Architectural Review Board Agenda
4:00 PM Wednesday, August 6, 2025
Sussex Civic Center – Committee Room Second Floor

MEMORANDUM

TO: Architectural Review Board
 FROM: Gabriel Gilbertson, Community Development Director
 RE: August 6, 2025 Architectural Review Board
 DATE: Friday, August 1, 2025

LANDSCAPE
PLAN

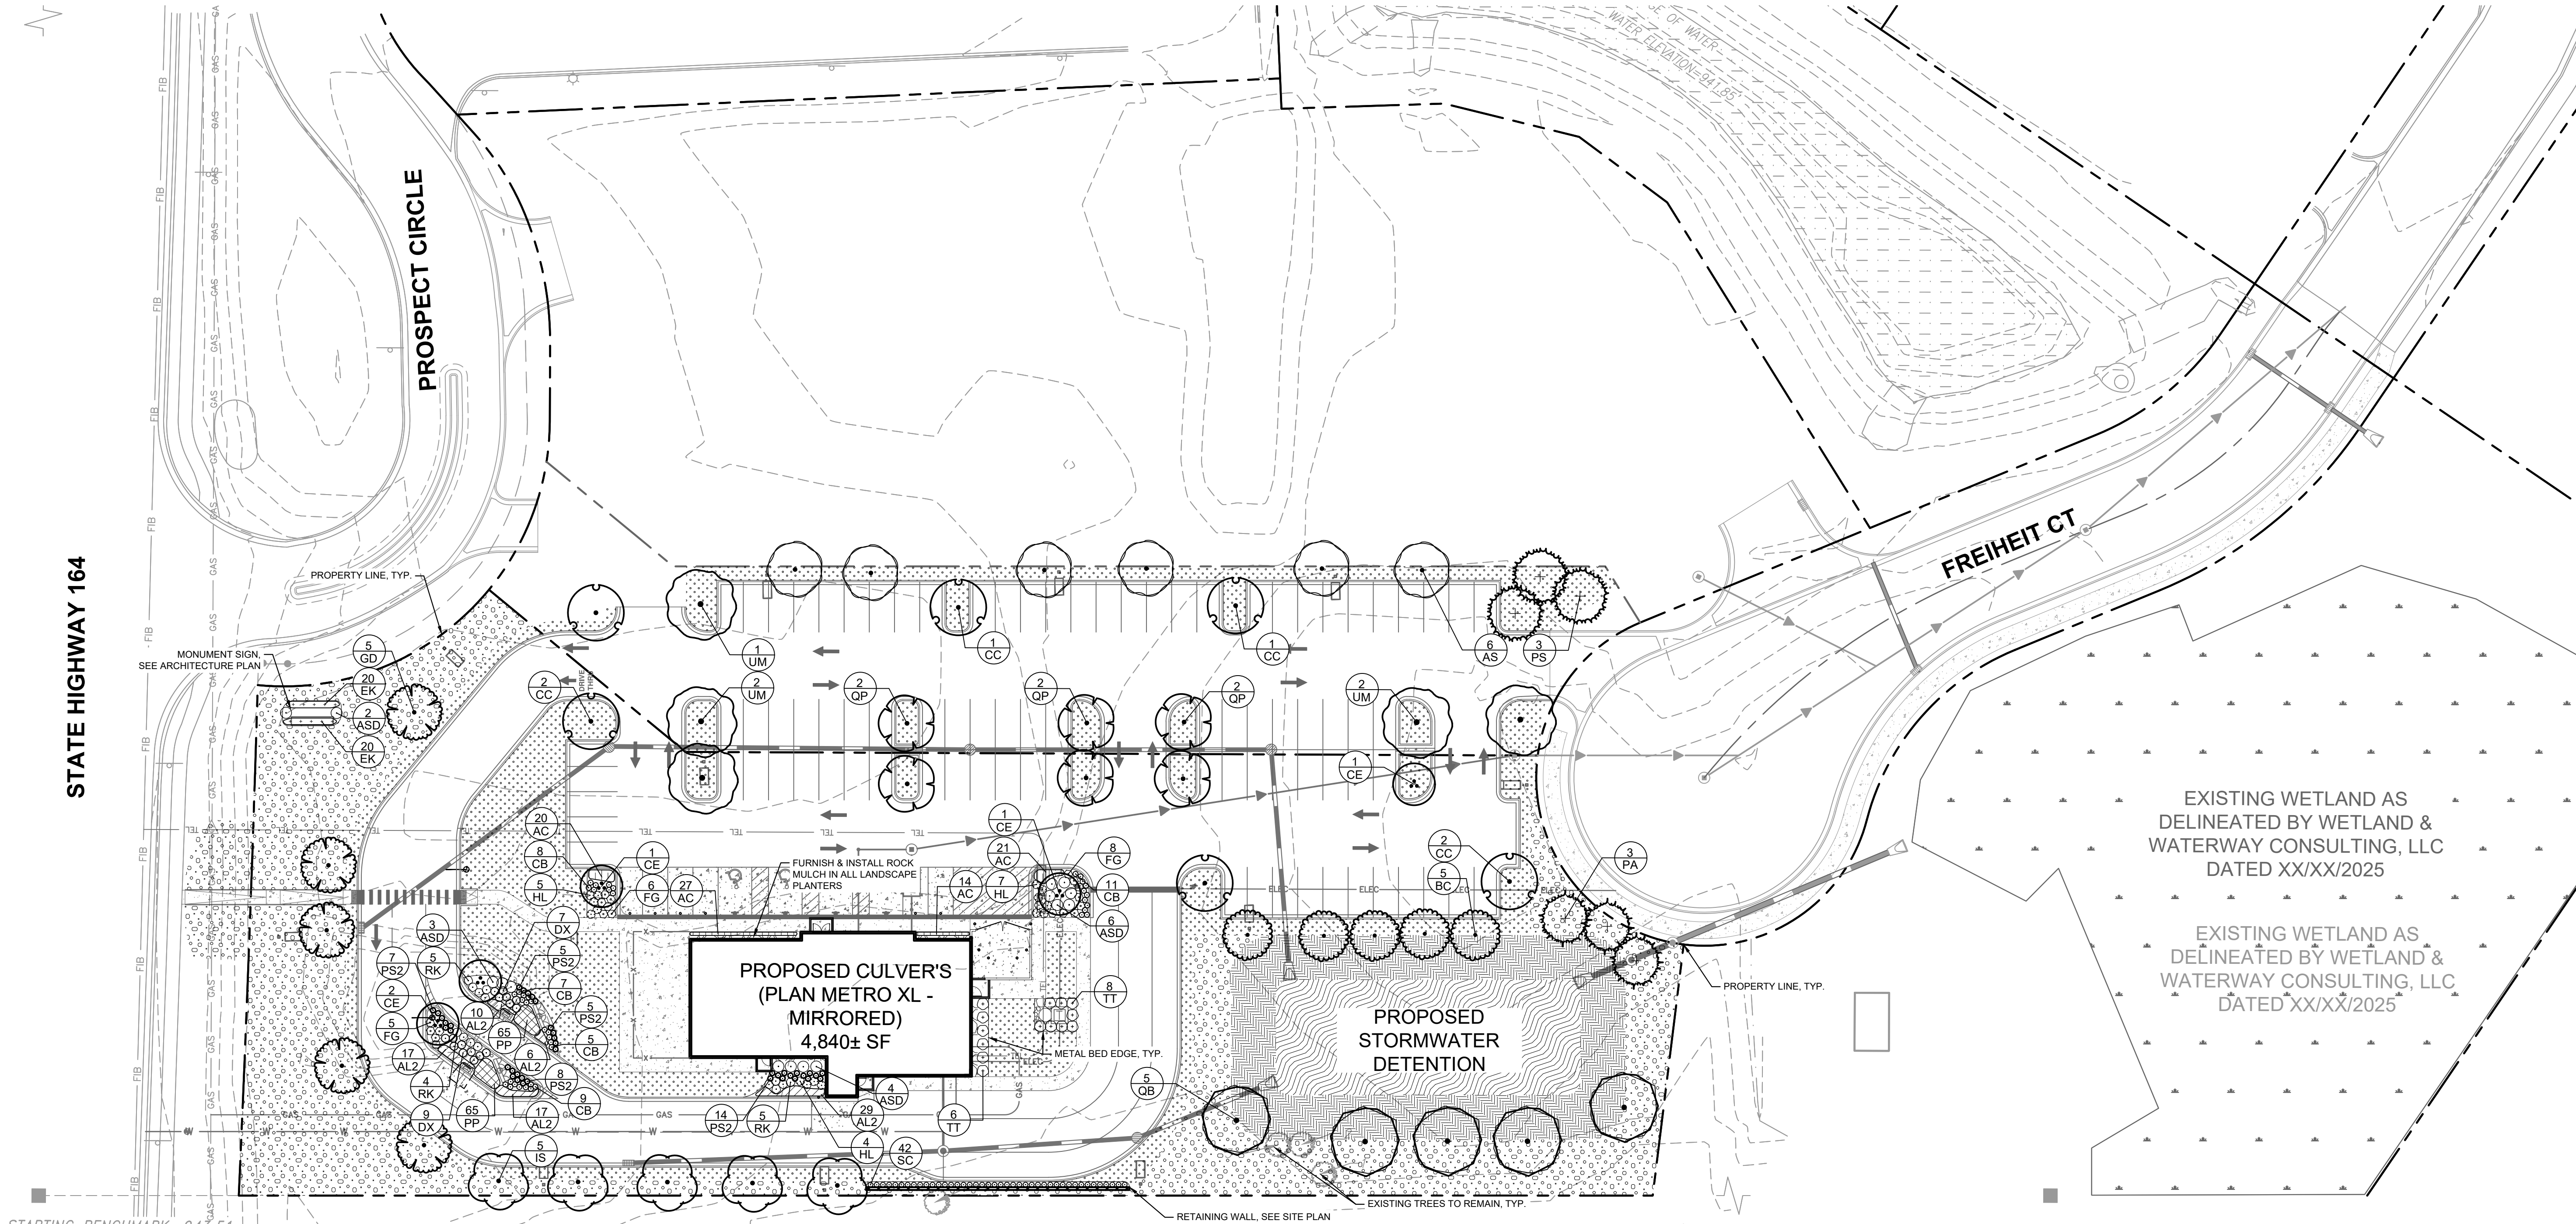
- The submitted landscape plan meets the minimum tree and flower/shrub requirements of the Sussex Design Standards.
- Landscape beds should be hardwood mulch – not stone mulch.
- There is 74” worth of trees that are being removed on the subject property. The applicant is planting approximately 135” worth of new trees and meets the requirements of the tree preservation ordinance.

WEST / FRONT ELEVATION

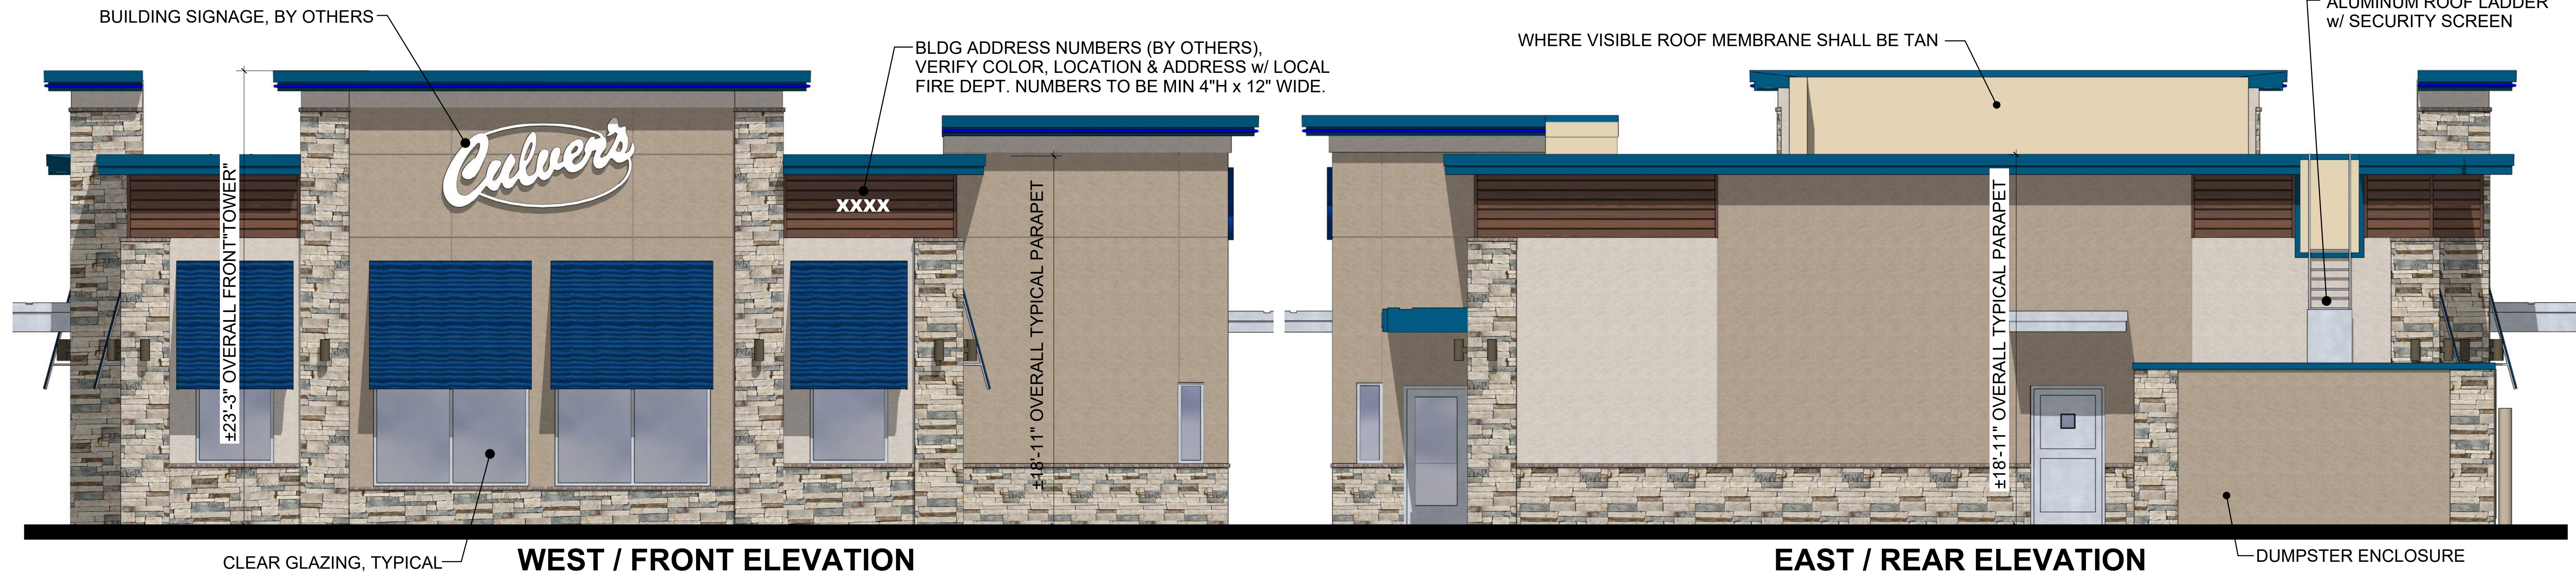
1. Are there any concerns with the submitted site plans?
2. The submitted plans do not meet the minimum 33% window/door opening on the street elevation facing STH 164. The applicant will need to request a waiver from this and will need to be approved by the ARB and Plan Commission.

1. Submitting a revised site plan with details for amount of greenspace.
2. Light fixture mounting height shall not exceed 25’.
3. Submitting revised elevations for the west side that meets the minimum 33% window and door opening requirements.
4. Submitting a revised landscape plan that includes lists hardwood mulch rather than stone mulch.
5. Light pole bases shall be painted to match the building. Submit details to Staff for review.

NOTE:
- AREA LIGHTS ON NEW 17 FT. POLES MOUNTED ON 3 FT. CONCRETE BASES
- FOOTCANDLE LEVELS CALCULATED AT GRADE USING INITIAL LUMEN VALUES UNLESS NOTED OTHERWISE.

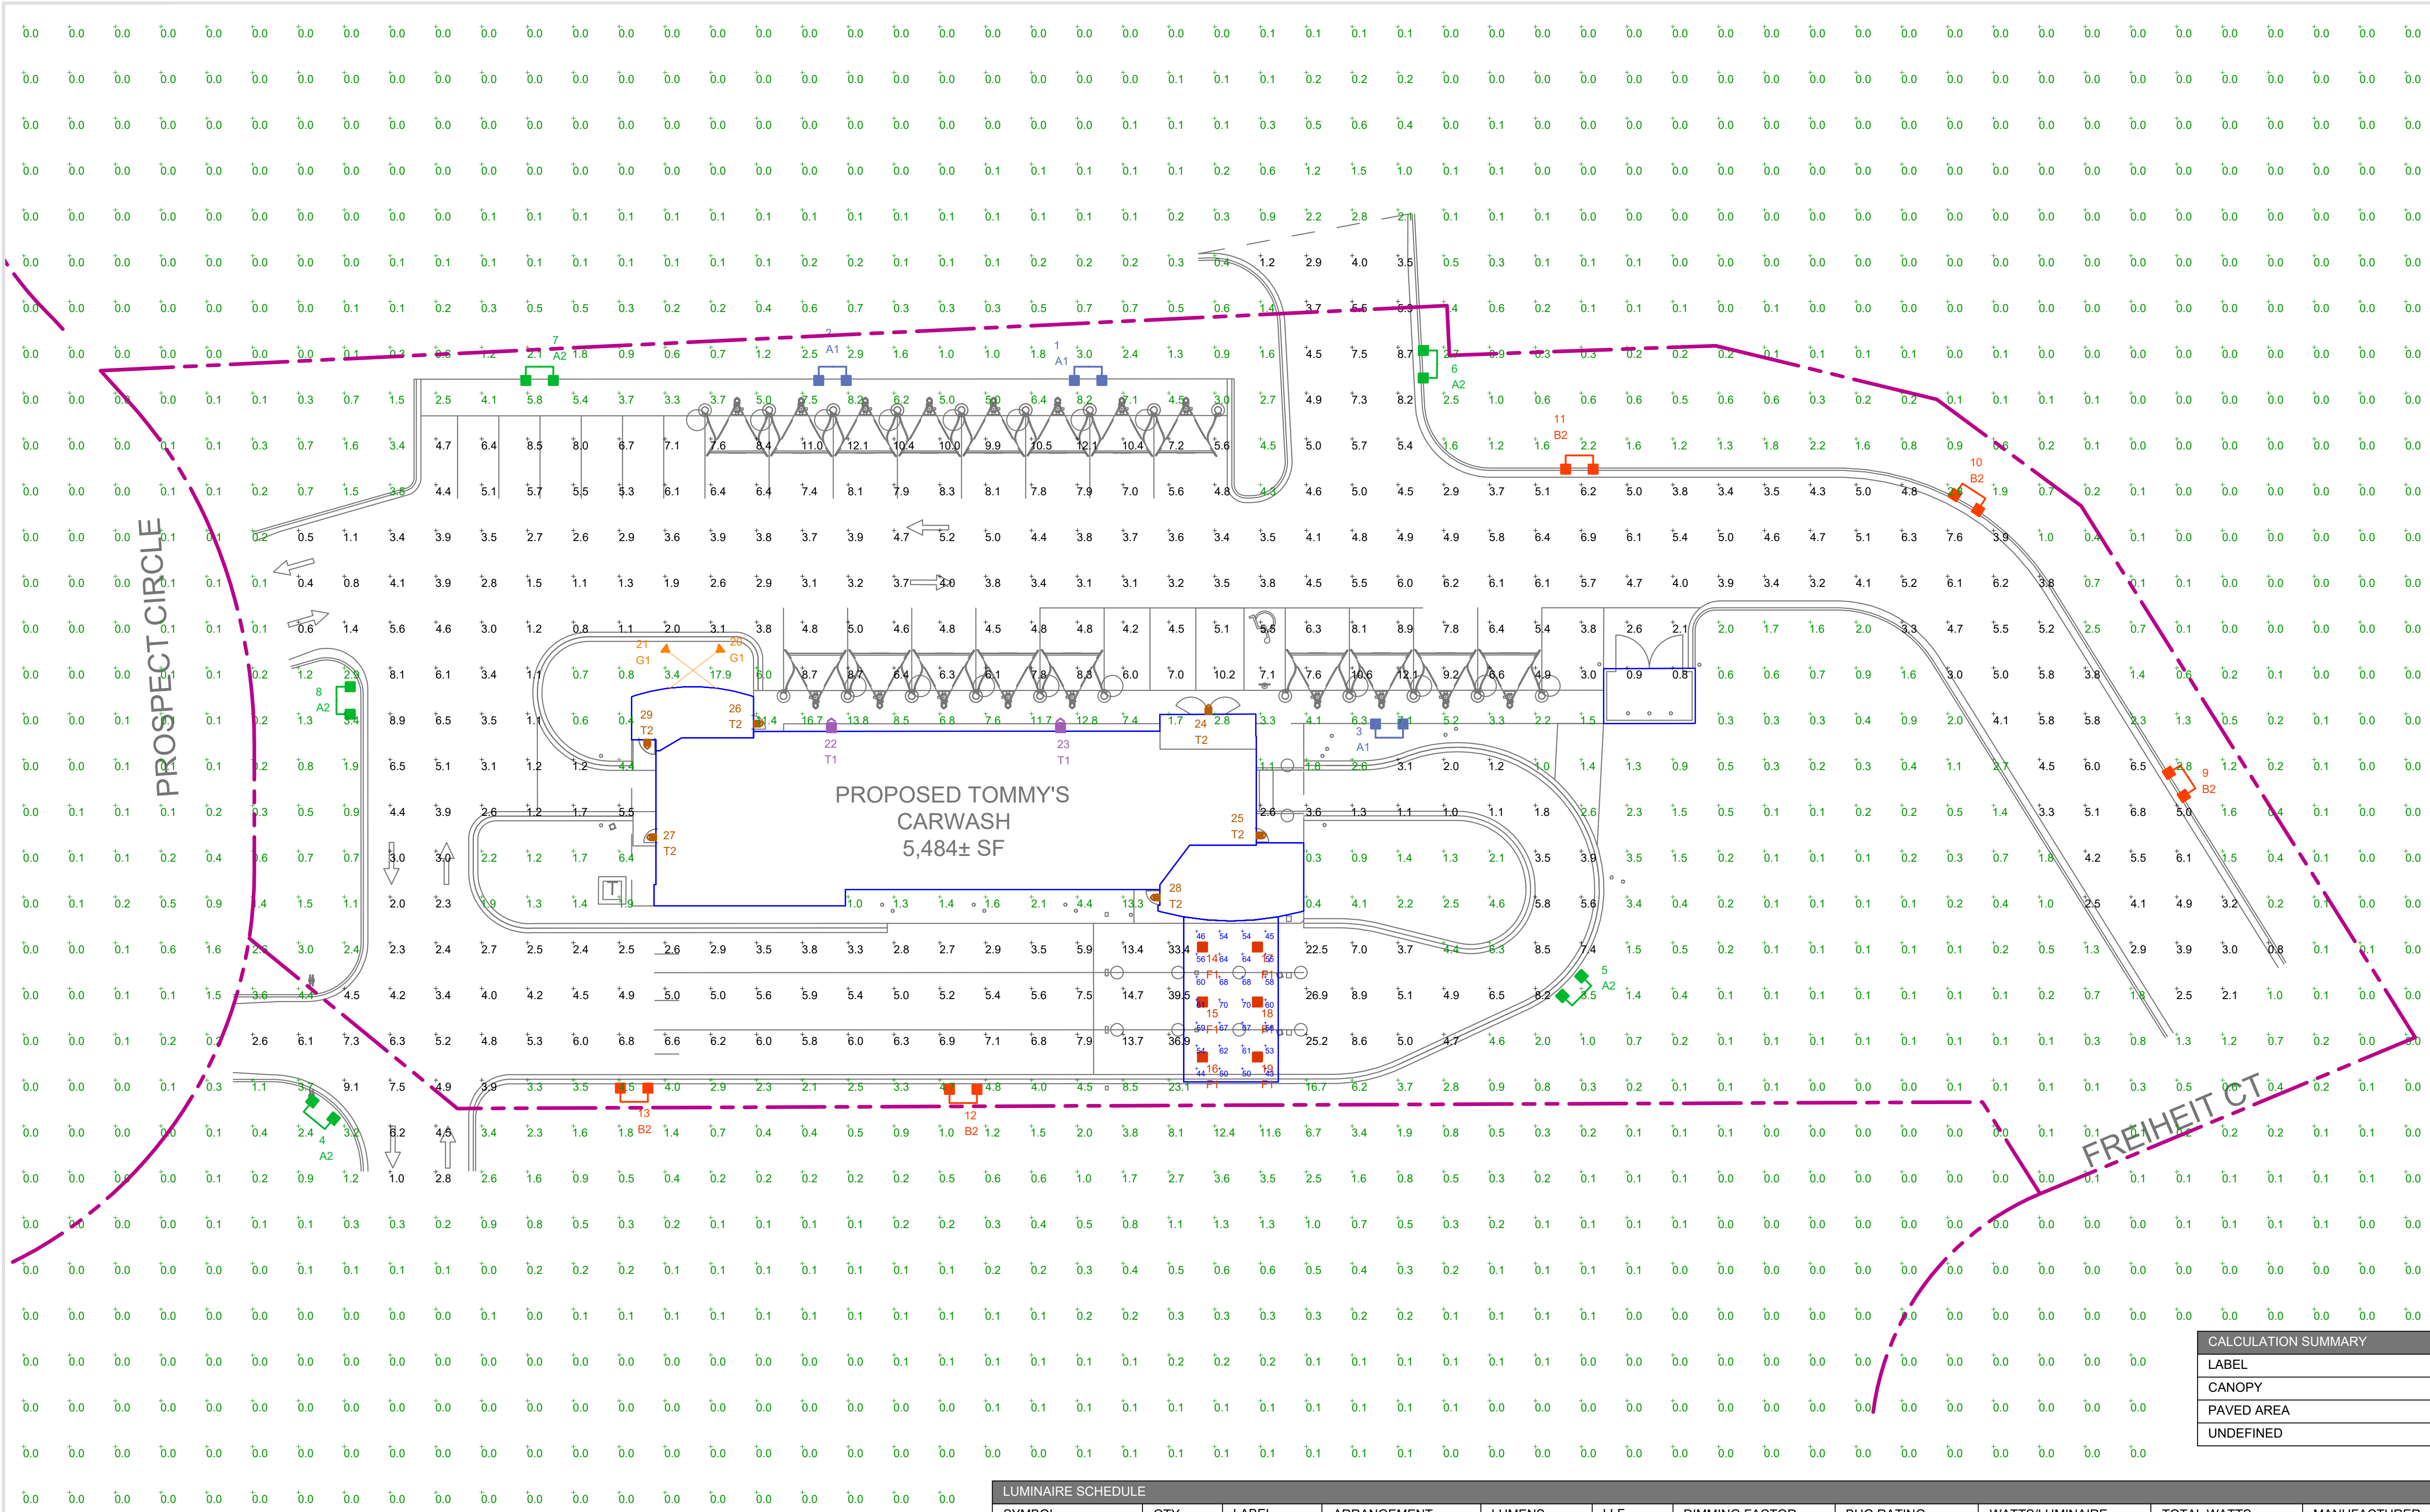
- The Municipal Code requires light at property lines not to exceed .2 footcandles. There are locations where the photometric plan exceeds .2 footcandles. The lights at the cross access drives are acceptable as that is providing light for the benefit of the access drive. However, the other locations need to be revised to reduce the light to .2 footcandles at the property line.

1. The Plan Commission approving the Conditional Use Permit for the proposed Tommy's Car Wash.
2. Submitting a revised lighting plan that meets the requirements of the Municipal Code to Staff for review.
3. Submitting revised elevations that meet the minimum window/door opening requirements to Staff for review or request an exception from the Design Standards.
4. Submitting a revised landscape plan that includes hardwood mulch rather than stone mulch to Staff for review.
5. Submitting elevations that include the trash enclosure and properly label the materials on the building with the corresponding material key for Staff to review.
6. Light pole bases shall be painted to match the building and details submitted to Staff for review.
